UNITED STATES PATENT AND TRADEMARK OFFICE

APPLICATION NO.	FILING DATE	FIRST NAMED INVENTOR	ATTORNEY DOCKET NO.	CONFIRMATION NO.
09/680,277	10/06/2000	Je Hong Kim	2658-0242P	8486

Office Action Summary

DETAILED ACTION

FIG. 4

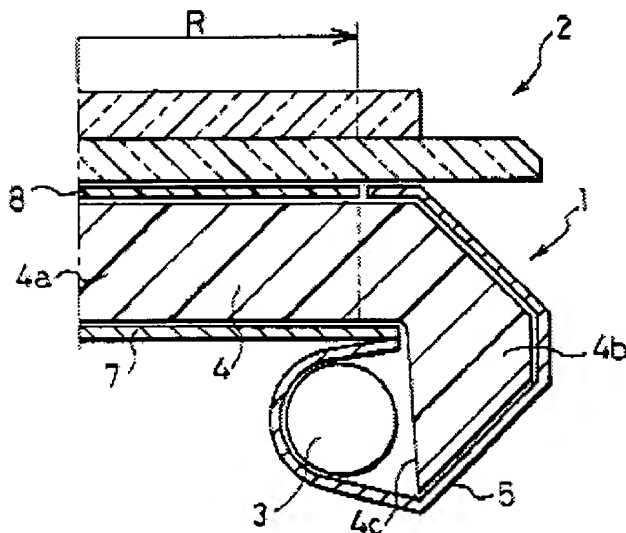
Oyama teaches in Figure 4 a light unit comprising a light-guide plate, 4a, and a reflector, 5, having a sectional view of spiral shape that efficiently guides the light (Applicant's high focus) from the light source to the light guide plate (col. 6, lines 13-24).

Oyama is evidence that ordinary workers in the art of liquid crystals would find the reason, suggestion, or motivation to add efficient reflection (high focus) to reduce bright lines in the display near the light source (col. 13, lines 33-52, especially lines 42-48).

Oyama teaches in Figure 4 a light-guide plate, 4a, installed at height different from the light, 3, input to reduce the outside dimensions of the entire apparatus with respect to the area of the display space (col. 2, lines 53-60) having a sectional view of spiral shape.

FIG.14(b)

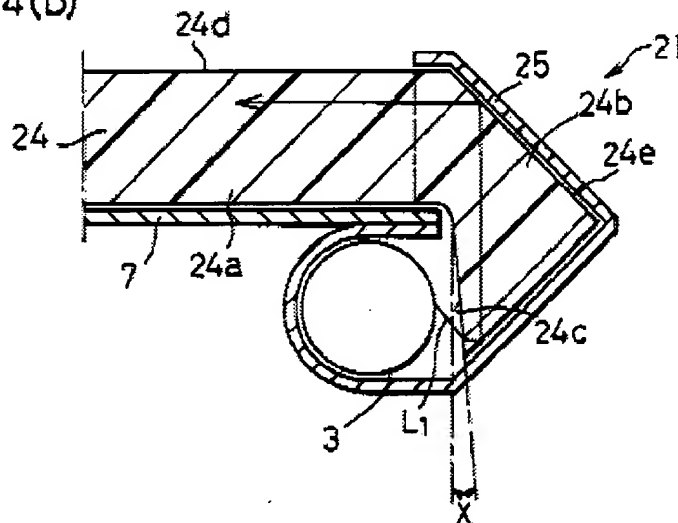
As to claim 5, Oyama teaches in Figure 14(b) a light unit wherein the reflective plate, 25, is curved to obtain a desired vertical incident angle of the light beam progressing to the light-guide plate to reduce bright lines in the display near the light source (col. 13, lines 33-52, especially lines 42-48).

Oyama is evidence that ordinary workers in the art of liquid crystals would find the reason, suggestion, or motivation to use a light unit wherein the reflective plate is curved to obtain a desired vertical incident angle of the light beam progressing to the light-guide plate to provide desired illumination characteristics.

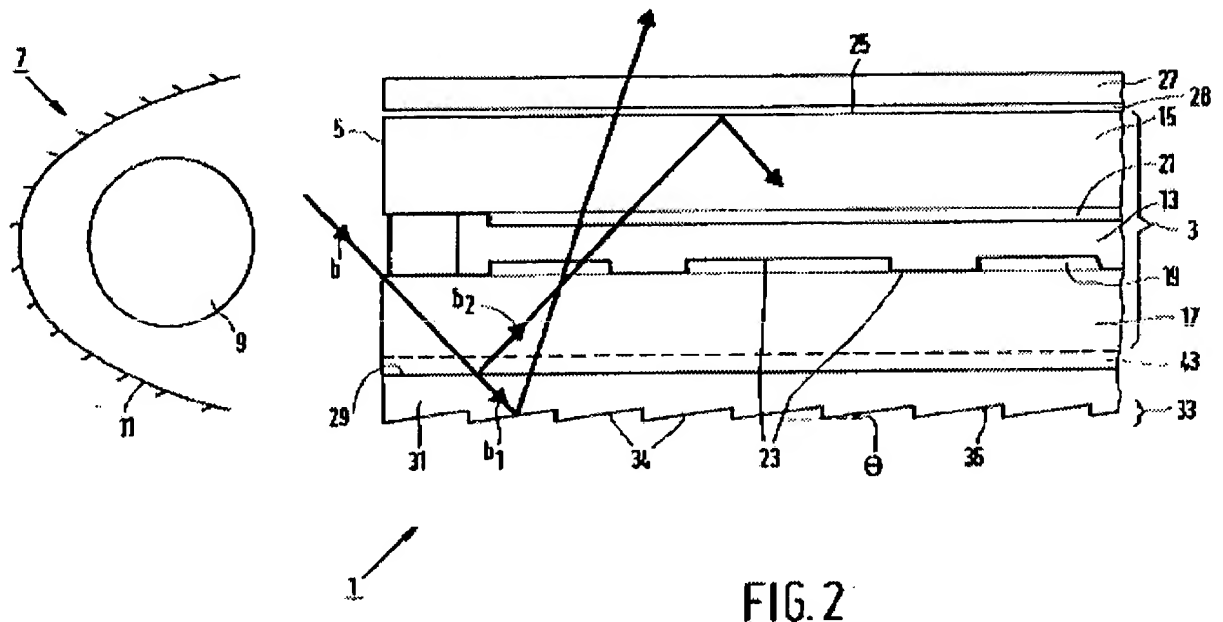
As to claim 7, Oyama teaches in Figure 14(a) a light unit wherein the lamp housing includes at least one reflective plate for cutting off the light beam progressing directly from the lamp into the light-guide plate, the at least one reflective plate being a protrusion of the inner surface of the lamp housing.

Oyama is evidence that ordinary workers in the art of liquid crystals would find the reason, suggestion, or motivation to use a reflective plate for cutting off the light beam progressing directly from the lamp into the light-guide plate, the at least one reflective plate being a protrusion of the inner surface of the lamp housing to provide desired illumination characteristics.

FIG. 7

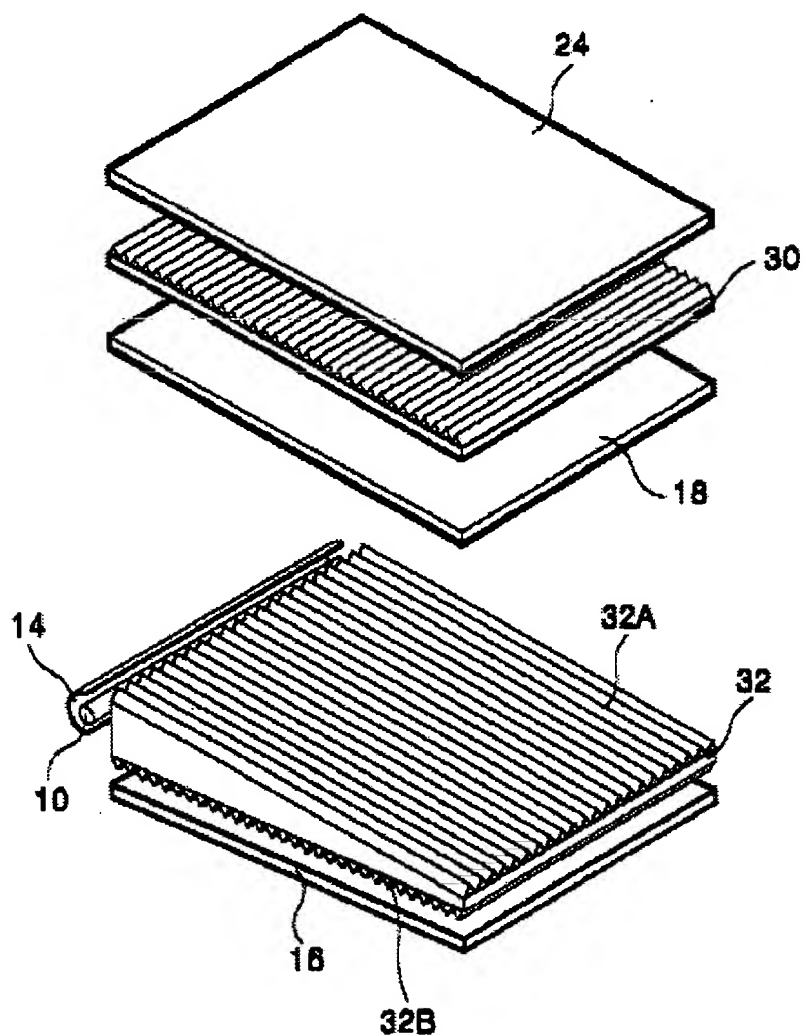
Kim teaches in Figure 7 the use of a light unit wherein the light-guide plate includes a plurality of prism patterns arranged on another surface thereof in intersection with the unit patterns.

Kim is evidence that ordinary workers in the art of liquid crystals would find the reason, suggestion, or motivation to add a plurality of prism patterns arranged on another surface thereof in intersection with the unit patterns to enhance the utilization ratio of the light generated by the lamp (col. 6, line 58 through col. 7, line 15).

FIG. 1

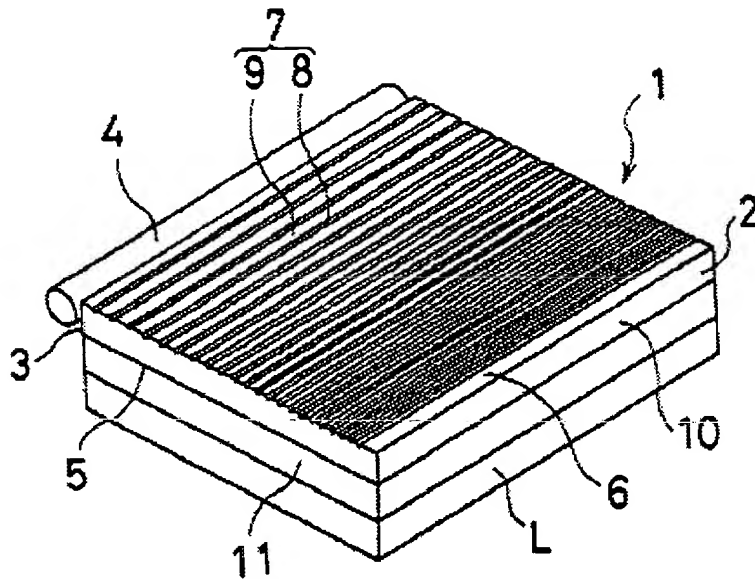
Egawa teaches in Figures 1 and 2 a light guide plate dispose on the front side of a liquid crystal panel to provide illumination without degrading contrast and without generating a moiré pattern (col. 4, lines 11-17).

Egawa teaches in Figures 1 and 2 a light guide plate wherein a distance between the unit patterns that gets gradually shorter as said unit patterns get farther away from the incident side of the light-guide plate so that the brightness becomes nearly uniform at any position in the transparent substrate (light guide) without being influenced by the distances from the light source lamp (col. 12, lines 34-50).
